COMMENTS & RESPONSES ON THE DRAFT INTEGRATED RESOURCE PLAN NOVEMBER 2024

Department:
Mineral Resources and Energy
REPUBLIC OF SOUTH AFRICA

ABSTRACT

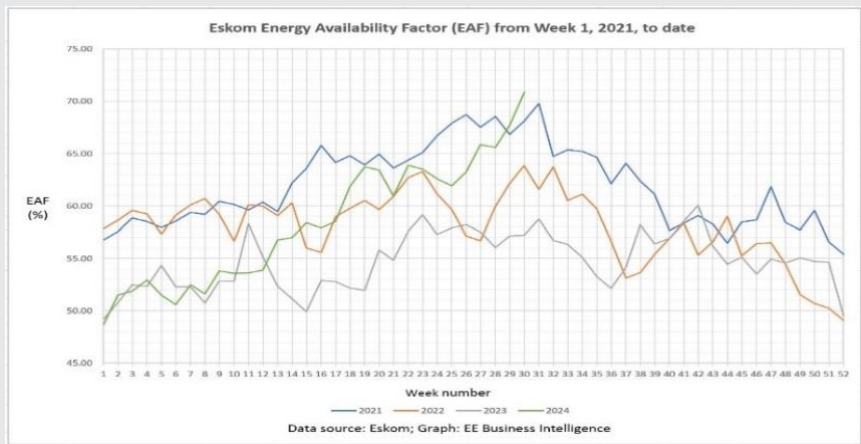
<p>5.19 The recommended sustainable growth rate is 3.8% per year, which is considered the maximum achievable level.</p> <ul style="list-style-type: none"> This target is significantly lower than previous goals <ul style="list-style-type: none"> ASGISA target: 6.5% per year NDP target: 5.5% per year Even achieving 3.8% growth is difficult due to the current state of the economy. A growth rate of 5% could unlock South Africa's economic potential due to its resource wealth. This would attract more domestic and foreign investment. However, achieving a higher growth rate requires strong political will, economic reforms, and social commitment. The 3.8% growth target translates to an electricity demand increase of approximately 3.0% per year. Increased electricity generation capacity (due to 3% annual growth) could lead to: <ul style="list-style-type: none"> Higher GDP growth More jobs Lower unemployment Improved living standards This growth scenario assumes policies are implemented to stimulate growth in industries and mining. 	<ul style="list-style-type: none"> We currently find it hard to come up with plausible drivers of a growth beyond the level in the new high growth scenario. ASGISA and NDP targets are aspirational and were also developed nearly a decade ago. Underlying domestic and international economic conditions have changed since then. National Treasury research (2019) shows that unlocking several key constraints facing the economy would only increase real GDP growth by between 2-3 percentage points above potential growth over the next 10 years. SARB potential growth estimate stands at 2.5%. Given current growth trends and short- to medium-term projections from the National Treasury and IMF, along with Treasury expectations of what is possible over the next 10 years, achieving 5% per annum growth over the 2024-2050 period would require growth of around 8% between 2040 and 2050 – this is unrealistic.

Recommendations:
5% demand growth a year to cope with an economy growing fast enough to reduce unemployment significantly.
